REPORT

File: PDP 16-01 AR 15-34

RE: Planned Development Permit 16-01 and Architectural Review 15-34 (Lava Ridge Apartments) – Vacant Lot Located at the Southeast Corner of Highway 32 and Bruce Road

ATTACHMENT G

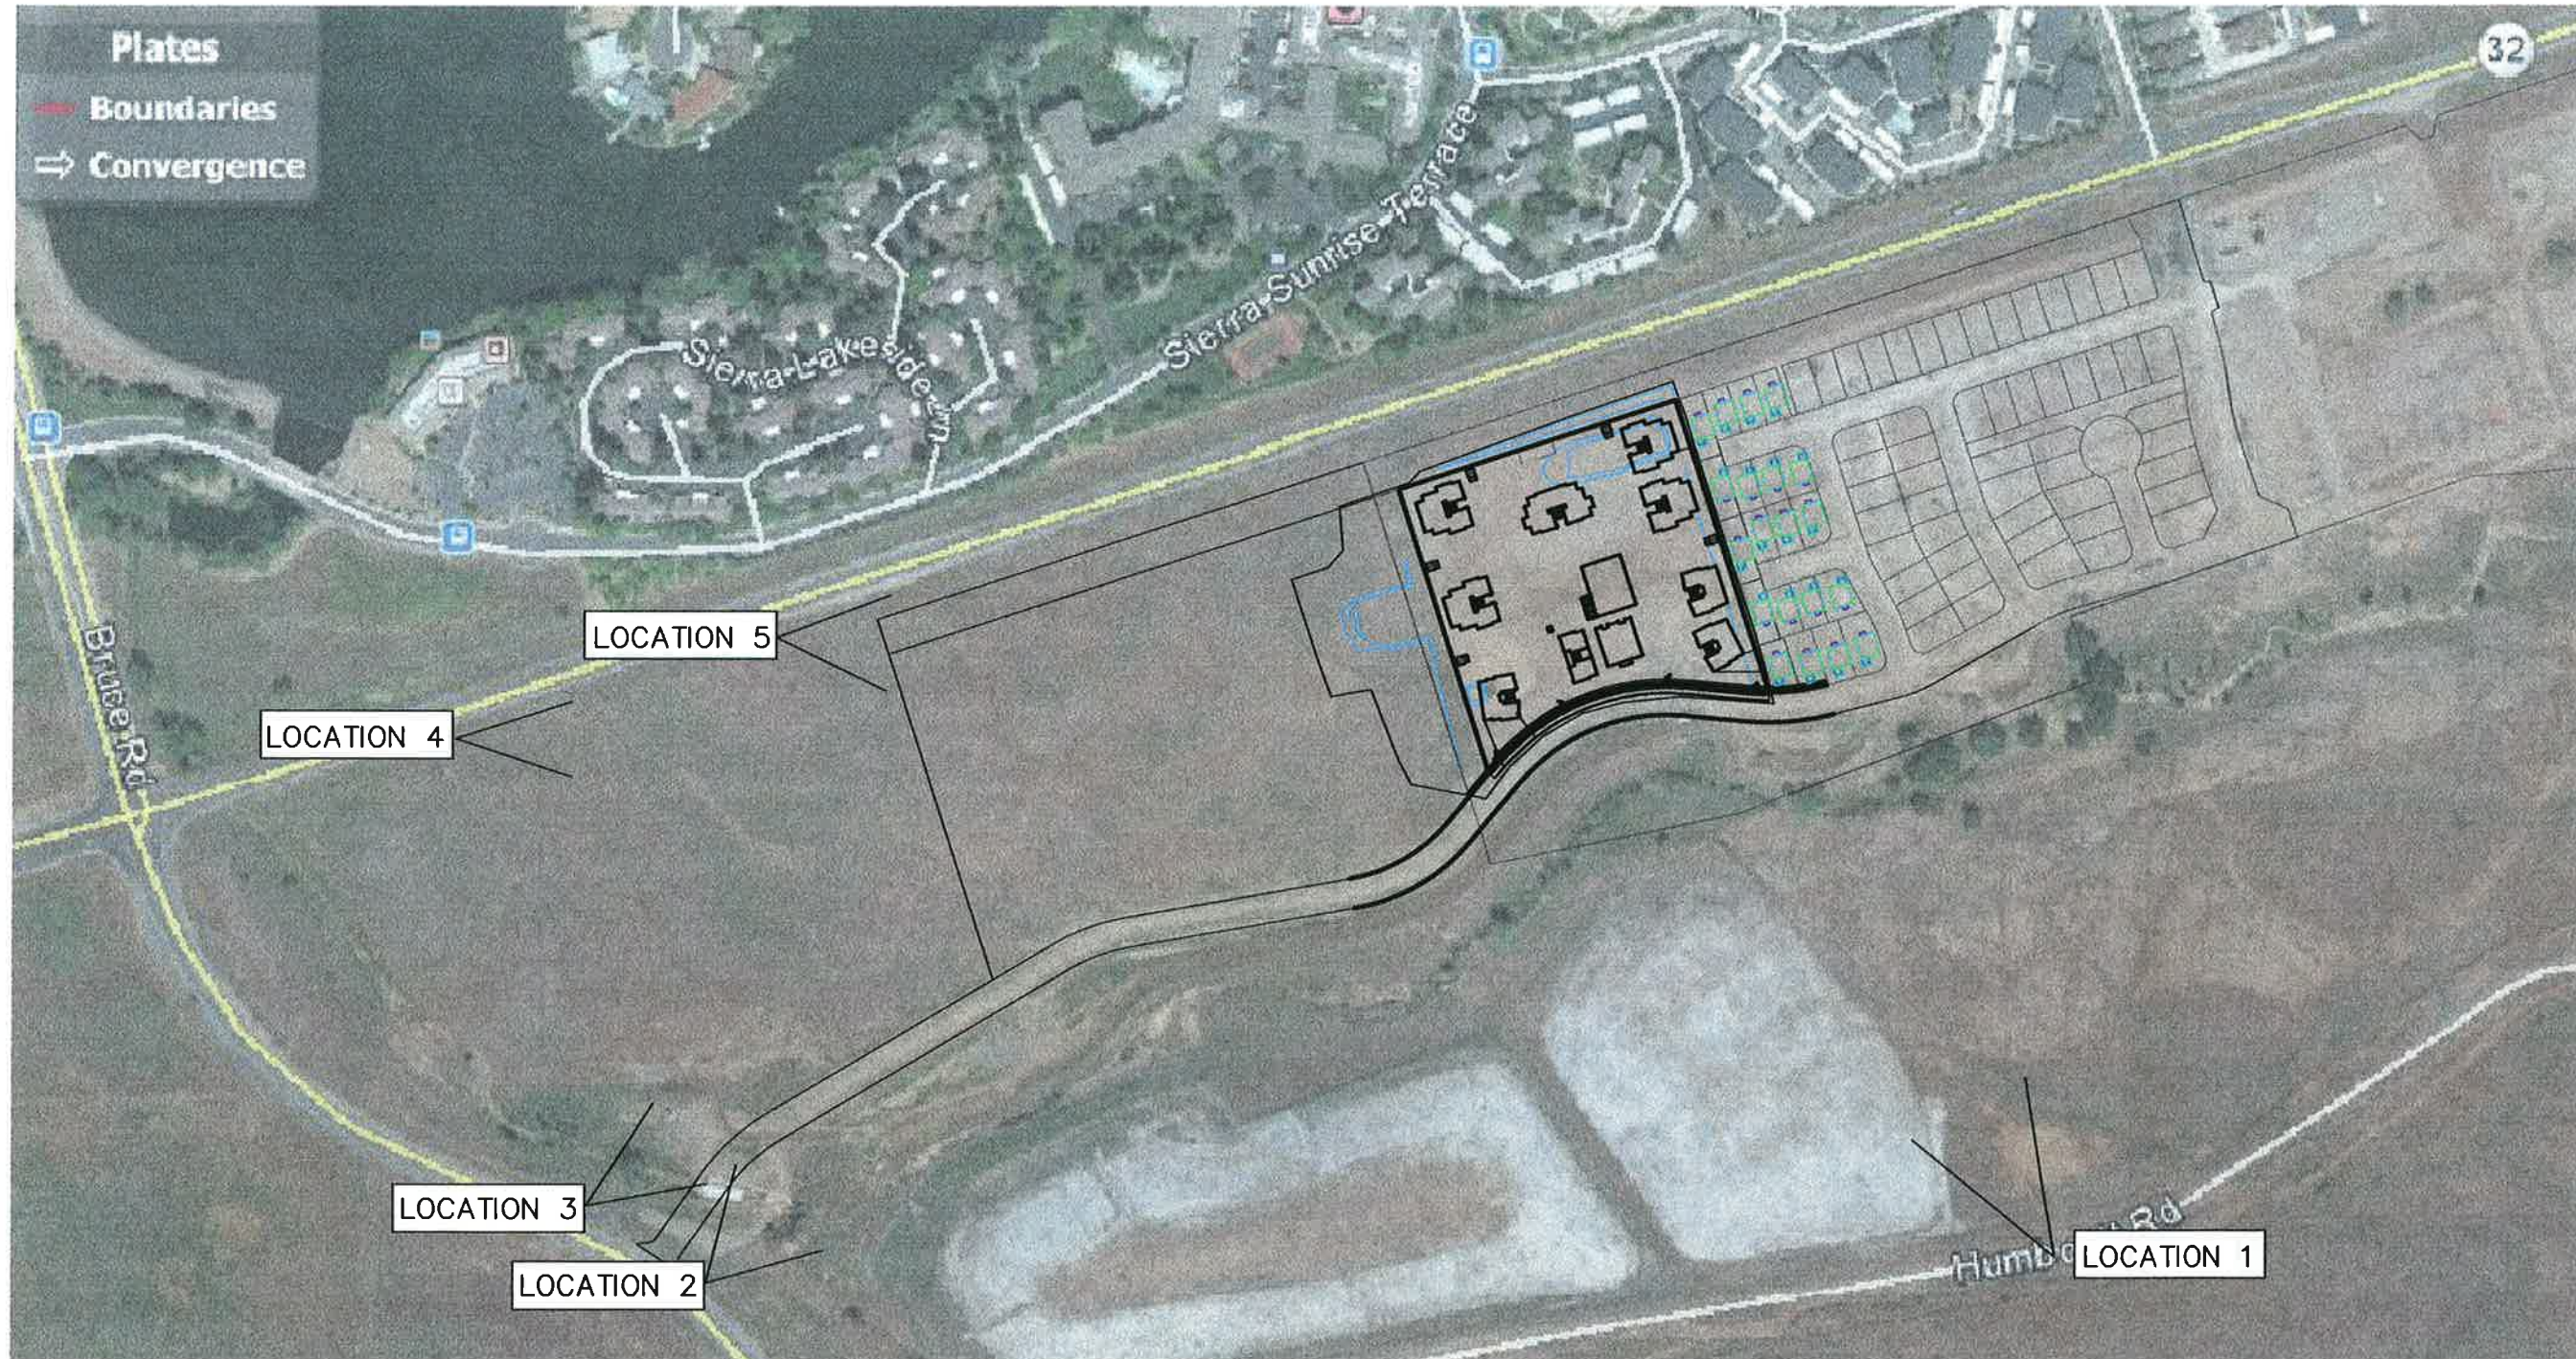
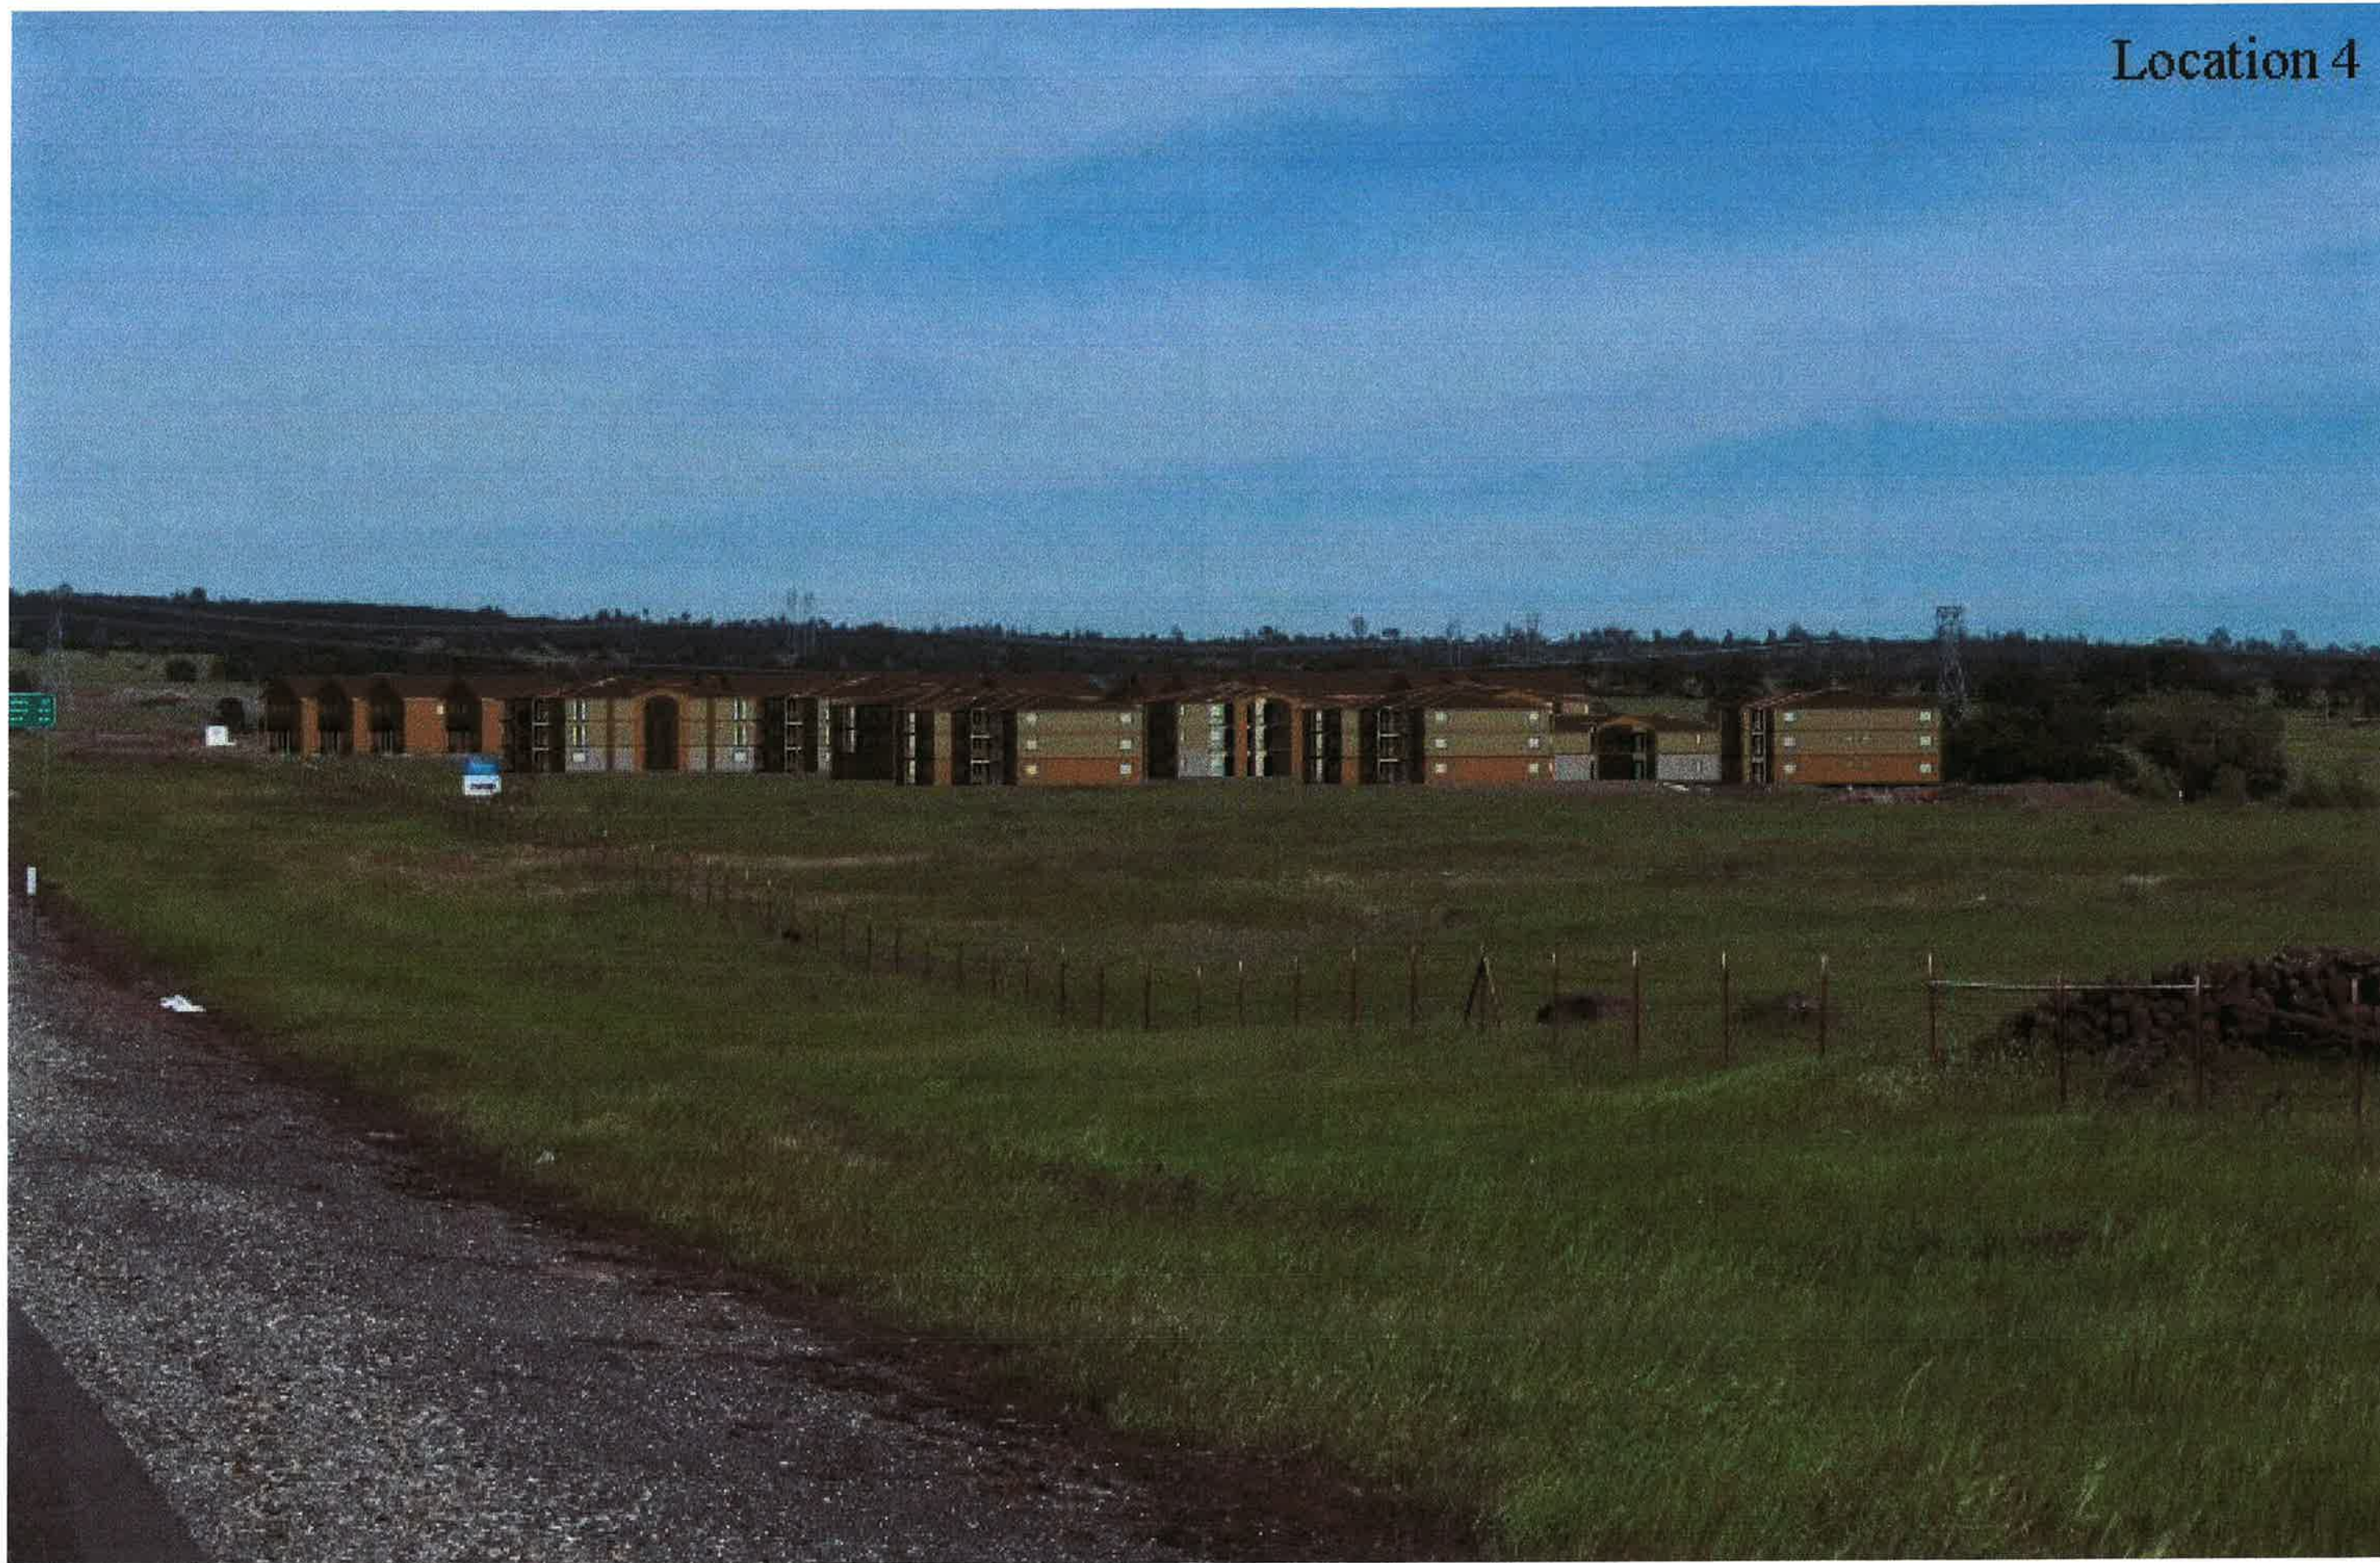
The subject site is located in overlay zoning districts that limit the height of structures to 25 feet. However, an additional 10 feet may be permitted if visual assessments can verify that greater building height will not negatively impact the foothill viewshed. The applicant has provided graphic representations of the structures from a variety of public right-of-ways to illustrate the project (see Viewshed Analysis, **Attachment G**).

For context, the Oak Valley Subdivision, at its western end is approximately 250 feet in elevation, and extends approximately 2,220 linear feet to the east, to an elevation of approximately 300 feet. The properties to the east will be developed with single family homes that have a height limitation of 25 feet.

Staff believes that additional 10 feet of height does not negatively impact the viewshed of the foothills to the east, as both homes and the elevation grades increase and will have an impact upon the viewshed. Staff recommends that the Board approve a condition of approval requiring the structures not to exceed 35 feet in height from finished grade.

3. Height of all structures is limited to 35 feet from finished grade.
4. Monument signage shall conform to Chico Municipal Code section 19.74 Table 5-8 prior to issuance of building permits.
